April 1, 2015
MEC Product Change Notification
Re: STANDARD Legends

Effective **October 1, 2015**, the legends for MEC caps will change to allow MEC to better and more quickly serve the majority of its customers as outlined below.

MULTIMEC CAPS

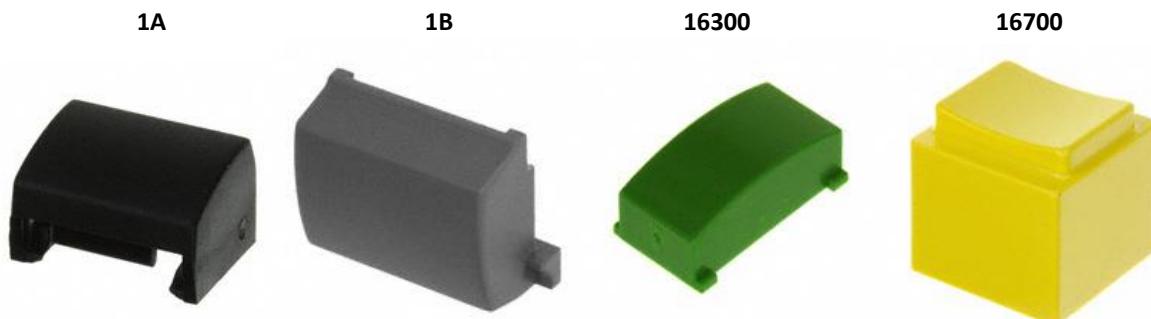
1A: no standard legends – all 1A caps with legends will be considered customs.

1B: 0-9 (legend codes 000-009) will be standard for both up and down versions. All other will be considered customs.
